Office Action Summary	Application No. 10/553,131	Applicant(s) BARGHEER ET AL.	
	Examiner HELENA KOSANOVIC	Art Unit 3749

DETAILED ACTION

(fig. 2 of Gallup)

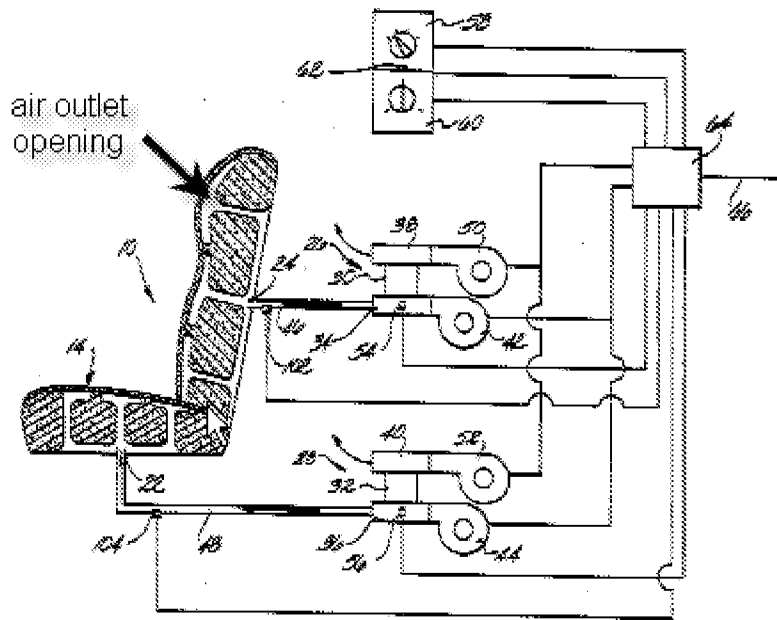
Regarding claim 8, an air supply device (fig. 2) for an automotive seat comprising: an air duct 46, which is arranged at the delivery side of a fan 42 and has at least one air outlet opening (see paragraph below where the examiner labeled originally not labeled elements with darkened arrow)provided in the upper region of the seat for supplying the head, shoulder and neck region of a seat occupant 12 with a flow of air, a heating element 34 arranged in the air duct between the fan and the air outlet opening, and at least one sensor 102 for detecting a parameter value as a function of which the flow of air emerging from the air outlet opening is controlled, wherein the sensor is arranged inside the air duct between (fig. 2) the air outlet opening and the heating element.

Regarding claim 10, wherein at least one of the heating element and the fan is controlled as a function of the parameter value detected by the sensor (fig. 2).

Regarding claim 12, wherein the grating element is arranged close to the air outlet opening of the air duct (fig. 2).

4. Examiner labeled originally not labeled elements with darkened arrow.

(fig. 2 of Brand)

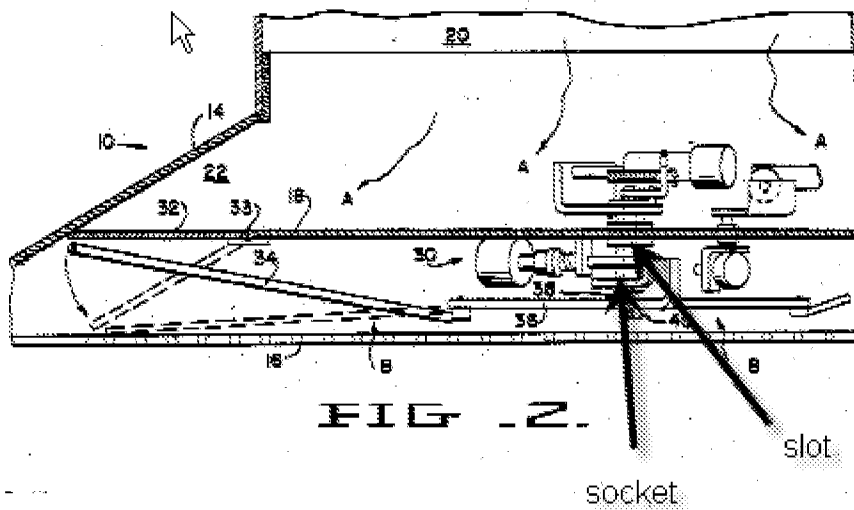
Brand teaches the sensor 30 (fig. 2) having a socket part (see paragraph below where the examiner labeled originally not labeled elements with darkened arrow) located in a slot (see paragraph below where the examiner labeled originally not labeled elements with darkened arrow).

It would have been obvious to one of ordinary skill in the art at the time of the invention to have the Gallup invention modified with the Brand sensor socket located in the slot in order to attach the sensor to the duct.
